## **MIDWEST POOLED FUND PROGRAM**

### **Progress Report - Fourth Quarter 2009**

Midwest Roadside Safety Facility  
Nebraska Transportation Center  
University of Nebraska-Lincoln

## **Pooled Fund Consulting Summary**

Figure 1. Pinned Barrier Rotation

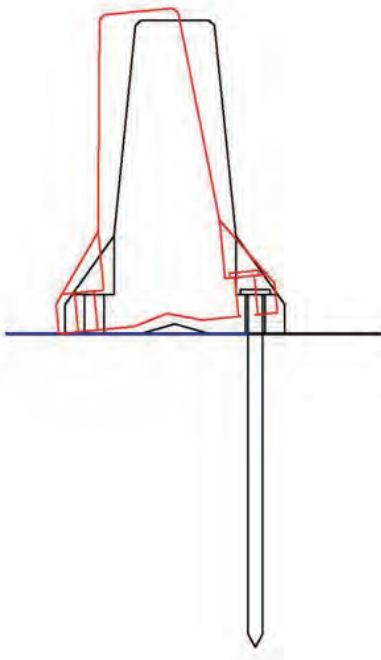
When consider the use of alternative barrier segment connections with the tie-down and approach transition applications, the loading of the barrier connection is significantly different, and the use of alternative connection designs with the F-shape PCB becomes more hazardous. Tie-down barriers have some form of constraint on the barrier. In the case of the tie-downs used in the F-shape PCB, the tie-downs consist of anchors that pass through the toes of the barrier and constrain lateral and longitudinal movement. This greatly affects the joint loading. When a tie-down barrier segment is impacted, the lateral and longitudinal translation of the barrier is limited by the anchors. Thus, the barrier edges do not generally contact and develop high tensile and moment loads at the joint. The majority of the tensile loads are developed by the tie-down. Because of the constraint and the lack of tension developed between the barrier segments, the behavior of the barrier system is such that the impacted barrier tends to deflect laterally and rotate back along its longitudinal axis. The barriers downstream of the impact have that motion transferred to them based on the shear and torsional loading of the barrier connection. Thus, as the first impacted barrier segment deflects laterally and rotates, the constrained, downstream barrier segments do not move until the shear and torsional loads are transferred through the joint. This creates a potential for vehicle snag on the end of the downstream barrier segment as it is exposed by the deflection and rotation of the impacted barrier unless the barrier connection can effectively transfer the shear and torsional loads to cause the downstream barrier to begin moving as well. This can be seen schematically in the attached picture.

Based on the different behavior and loading of the barrier connections in the tie-down configuration, we would not recommend using alternative barrier connection designs unless the barrier connection was shown to provide greater shear and torsional capacity along the longitudinal axis of the barrier than the pin and loop connection used in the tested design. In addition, the connection would need to develop those loads relatively quickly (i.e., the barrier connection would have to develop loads before excessive rotation of the impacted barrier segment caused potential snag). Failure to meet these conditions could potentially result in vehicle snag on an exposed barrier end and corresponding excessive vehicle decelerations and instability. We have observed some degree of vehicle snag in the tie-down and approach transition testing conducted on the F-shape PCB. The difference in the loading of the connection between free-standing and tie-down barrier systems makes it very difficult to infer the performance of alternative connections in tie-down applications without full-scale crash testing. Thus, we would not recommend alternative barrier connections for the tie-down F-shape barrier or its associated transition designs without detailed analysis of the load capacity and behavior of the alternative joint or full-scale crash testing.

Figure 3. Low Tension Cable Terminal Lever Retention Cable

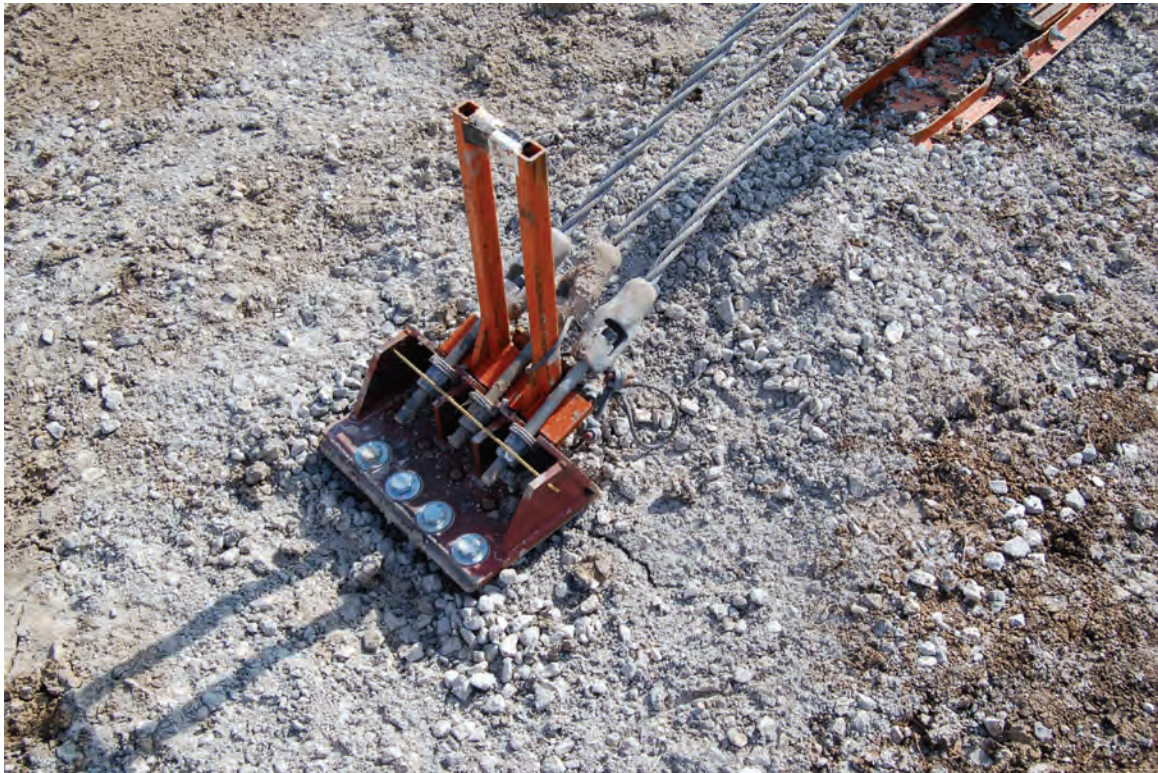
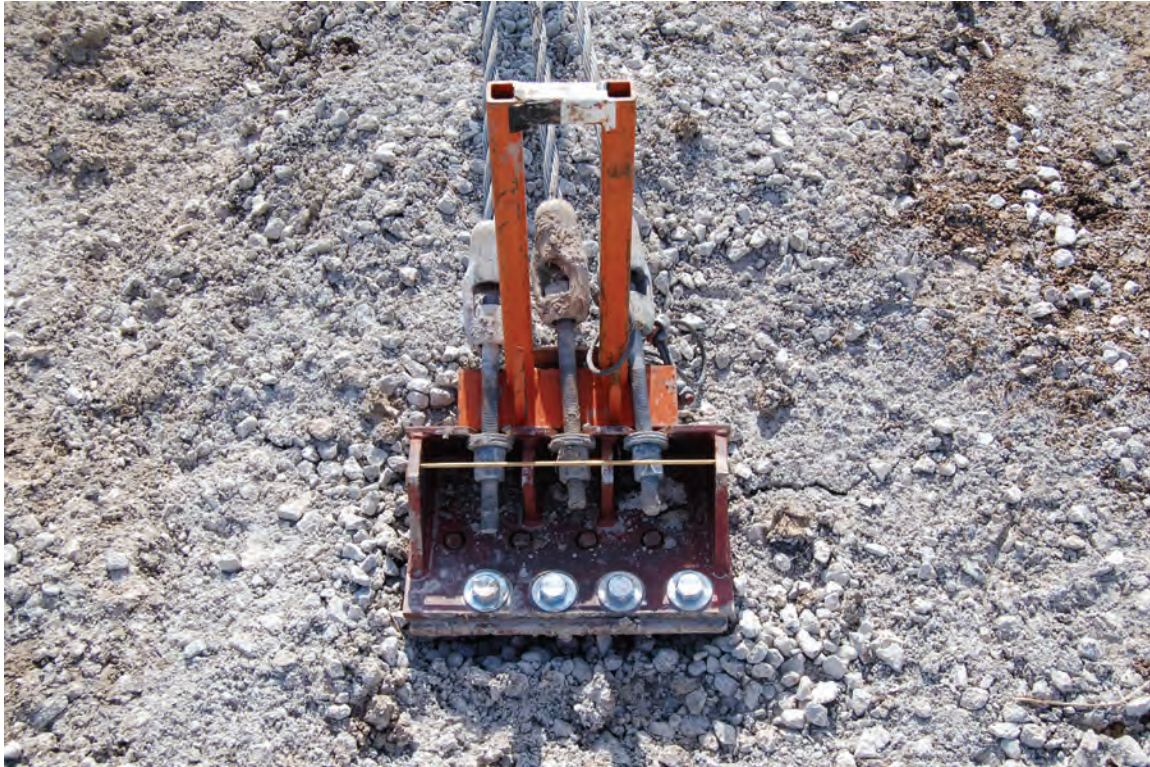
Should there be a light weight tie down cable to keep the cable release lever from flying somewhere it shouldn't go?

- Yes, there should be a retention cable. It should be 1/4" diameter 7x19 aircraft cable. The cable should be 36" long and formed into a loop with 1" cable clips. See attached photos.
- One other note. The CAD details show the use of 2 washers on the end fittings that connect to the cable plate. This is incorrect. We used a minimum of three washers on the end fittings. As an alternative, we designed 3"x2.125"x0.5" plate washers for the high tension design. These would be acceptable as well.

Figure 4. Low Profile Barrier End Section Details

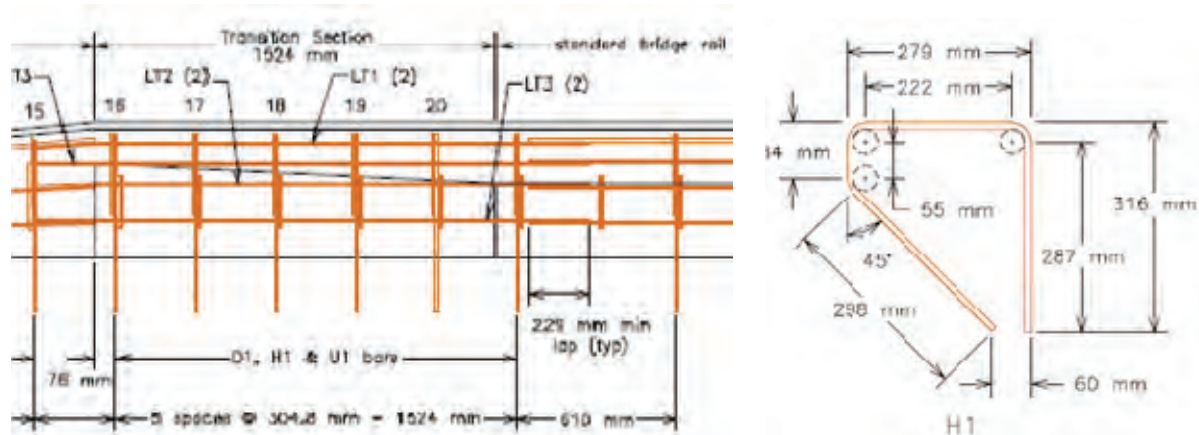
Quick question, we were detailing the low profile barrier and noticed about 5 extra H1 bars in the transition section with a total of 10 H1 bars. Can you explain the extra H1 bars in your table and the footnote a little more? The detail came from Iowa but originally came from MWRSF.

Based on the detail you sent you have more H1 bars than you need in the transition section.

It appears that the report shows only 5 H1 bars in the transition section, but the table states there are 10. We believe that the table is in error and that the CAD is correct.

Figure 5. MGS Approach Transition with Omitted Post

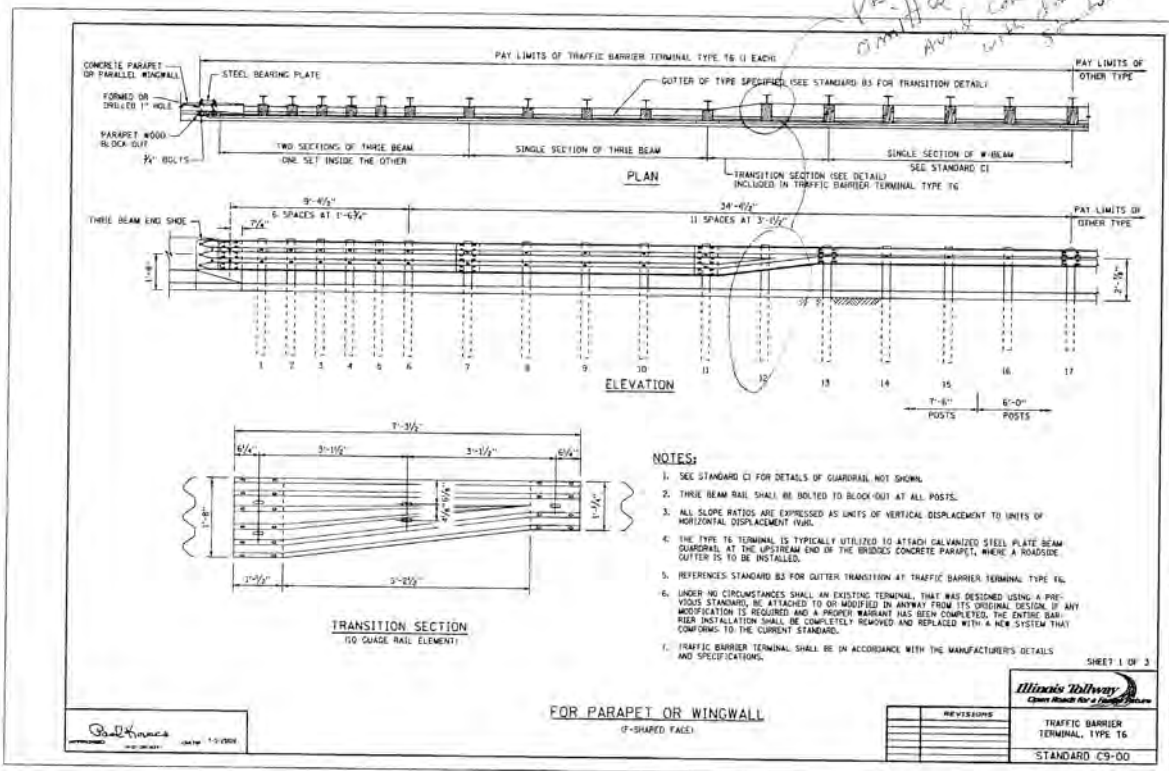
Post #12 (the middle post in the asymmetrical transition piece) was omitted to avoid conflict with a drainage structure. See attachments. Is this allowed or what recommendation would you have for this detail?

Over the last year or so, I have fielded a few inquiries regarding the inability to place a post in a transition region due to a pipe culvert flowing out of an curb inlet. In past inquiries and depending on the transition used, I have suggested using a simulated post at such a location. I believe you are depicting the transition that used W6x12s by 90 in. long in the noted region. If we wanted to replace the midspan capacity, it would seem reasonable to use two W6x9s by 72 in. long posts – one on each side of the lateral pipe and behind the rail. Then, a WF beam would be placed between the two posts. This beam would be used to support a deep blockout and allow the two smaller and shorter posts to serve a one post where it could not be placed. Of course, this surrogate system has not been actually designed for your case but would be a concept that likely would work in this scenario. It would give back the resistive capacity at a location in the transition that may be prone to vehicle pocketing and snag. Let me know what you think.

Figure 6. Proposed Iowa Layout for TCB to Bridge Rail Connection

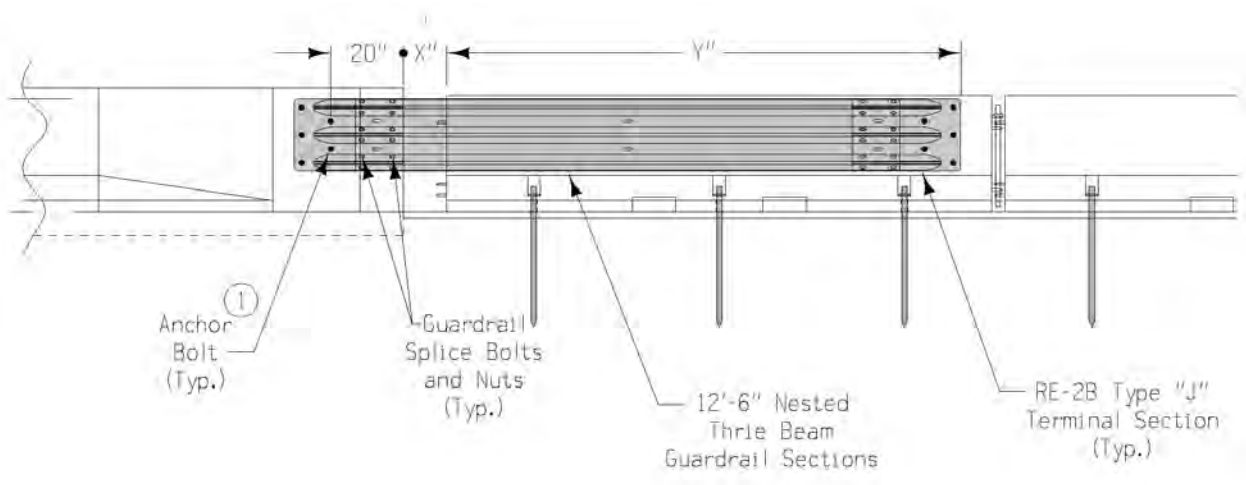
As we spoke on the phone, I have a question regarding the roadside TCB to bridge connection utilizing thrie-beam panels. Do you or Bob have any rules of thumb regarding how the length of thrie-beam sections should be distributed onto the bridge and the first TCB section? For example, I would like to connect the thrie-beam end shoe to the bridge through existing bolt holes. This would place a significant majority of the thrie-beam length onto the first TCB section (see attached file). Do you see any issues with this approach?

Upon further inspection, I realized that my scaling was off on the thrie-beam section I showed in my drawing. Having corrected that, and using the dimensions to the existing bolt holes in the bridge rail and a 12-inch gap between the bridge and the first PCB, I am now showing that the thrie-beam piece will extend entirely beyond the first PCB section. I assume this is an issue (maybe not?).

Minimizing the gap between the bridge and the first PCB would allow bolting the rail into both the first and second PCBs. Would this be acceptable? Are there any other spacings or modifications you might recommend, such as using a shorter thrie-beam section?

I don't like the idea of extending the thrie beam past the end barrier in either of those schematics. If we do so, the thrie beam is no longer tied to the end barrier. In addition, the 12" gap detail would create a snag hazard on the thrie beam end shoe.

Figure 7. NDOR MGS Approach Transition

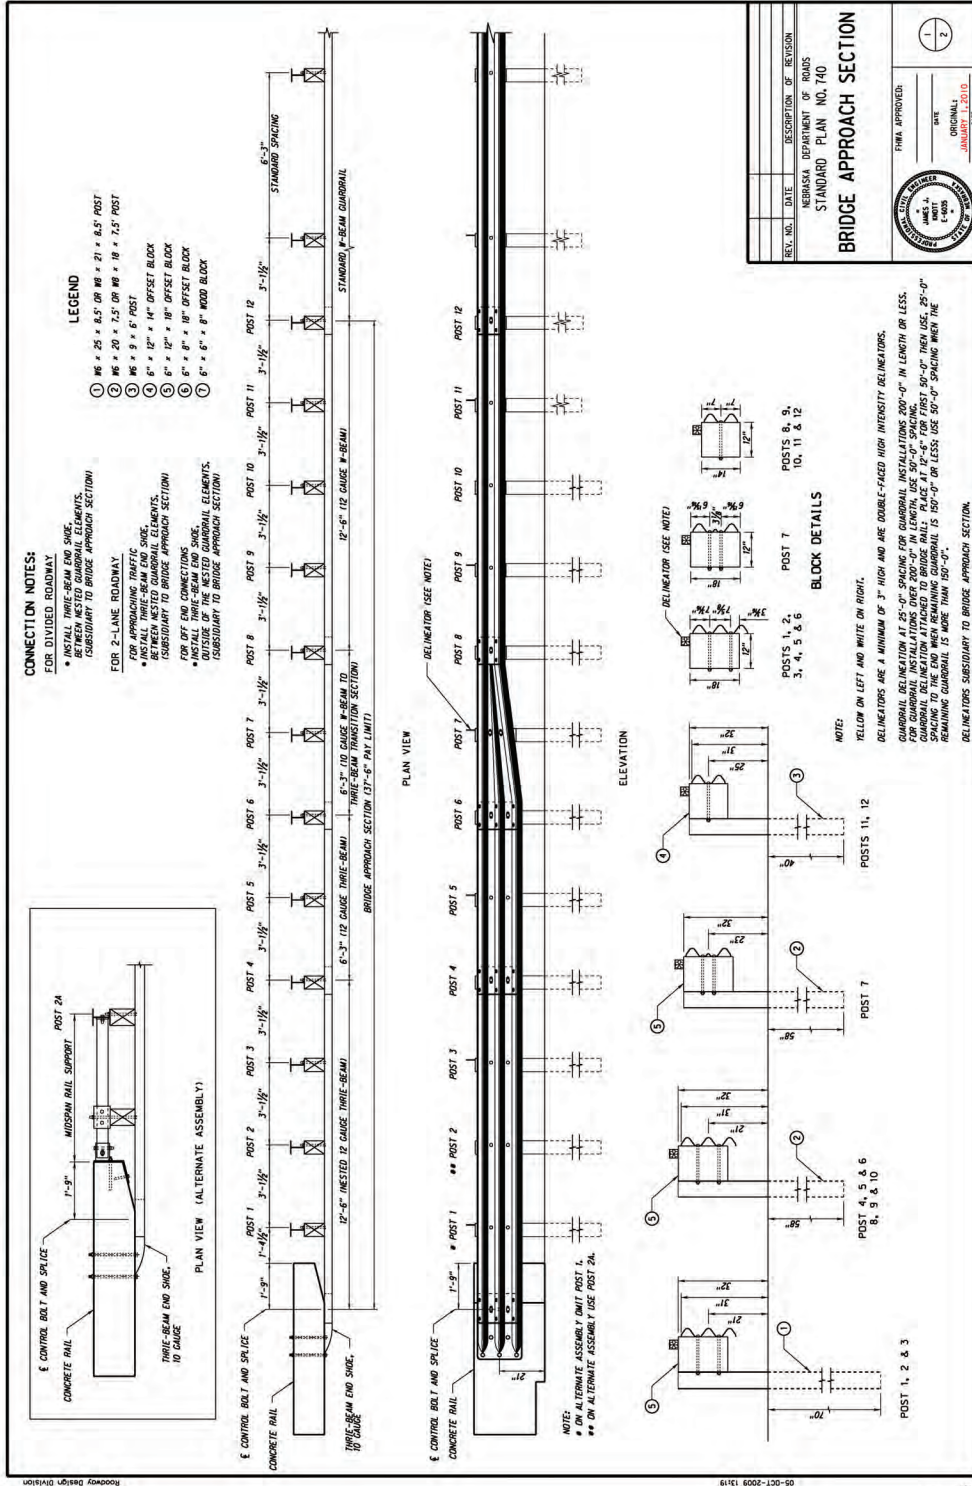
What end treatments are available for 31” guardrail?

File “MWT FD R0” shows the design which utilized 3 W6x15’s (7 ft long), 7 W6x12’s (7 ft long), and 2 W6x9’s (6 ft long). The transition length of this system – as defined in your drawing as the distance from the bridge rail to the DS end of standard MGS rail segment (additional post at this location) – is 37.5 ft.

File “MWT-SP R4” shows the design which utilized 3 W6x15’s (7 ft long) and 7 W6x9’s (6 ft long). The transition length of this system – as defined in your drawing as the distance from the bridge rail to the DS end of standard MGS rail segment (additional post at this location) – is 25 ft.

In order to soften the approach transition but still keep the large W6x25’s, the transition length will have to be increased. As stated previously, I like the transition between the W6x25’s and the W6x20’s, so nothing will change on the DS end of the transition. To attach either MwRSF designed approach transition, the W6x20’s will be used to represent the W6x15’s of the tested MwRSF system. Both W6x20’s and W6x15’s have 6 in. wide flanges and the embedment depth of the two posts is only changed by 0.5 ft. The additional stiffness provided to the W6x15’s by rail cap used in the MwRSF system should make the total stiffness similar to the W6x20’s with a slightly deeper embedment.

To answer your blackout question: I would keep the blackout depth at 12 in. for the W6x25's and W6x20's (I'm assuming that was the blackout depths of the system as tested). Thus, the DS end remains the same as tested and accepted. Additionally, the increased blackout depth of 4 in. (12 in. deep blockouts on the W6x20's are replacing the 8 in. deep blockouts on the W6x15's used in the MwRSF system) can be thought of as an extra safeguard to prevent snagging between the untested transition between the W6x20's and the approach guardrail transitions.

Figure 9. Type 6 Terminal Sections

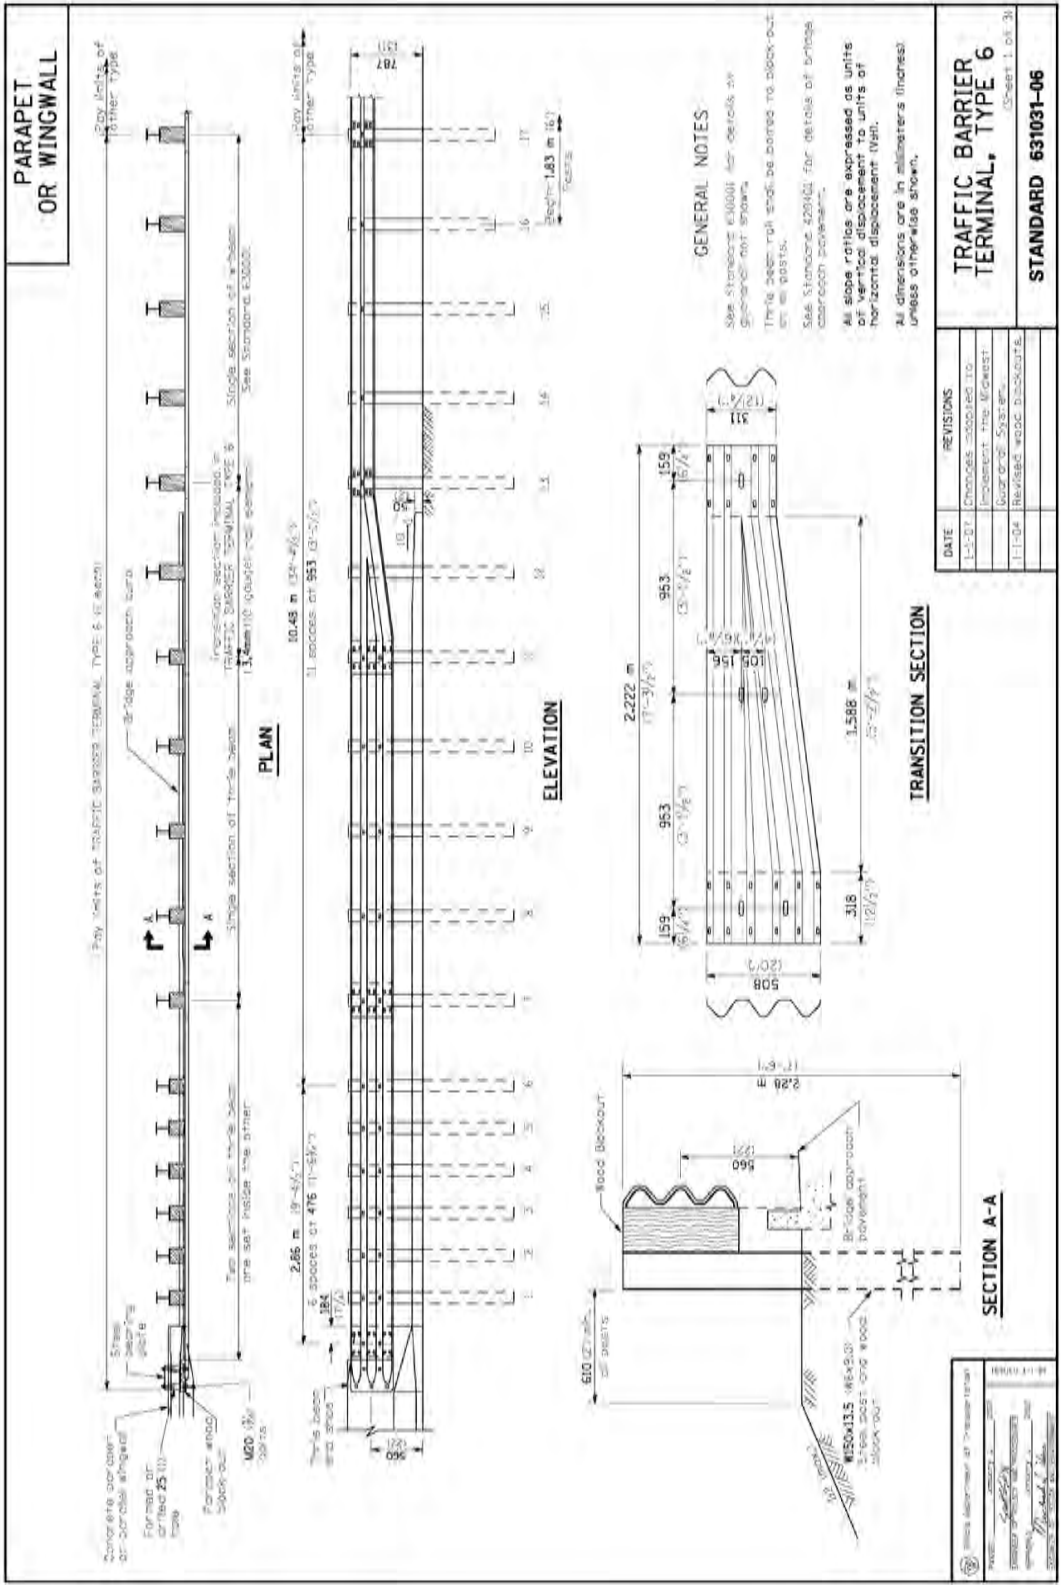
Jay Chiglo with HDR in Chicago, IL had questions regarding the proper connection between the Iowa approach guardrail transition and various concrete parapets.

Please let me know if you have any other questions or comments regarding the information contained herein.
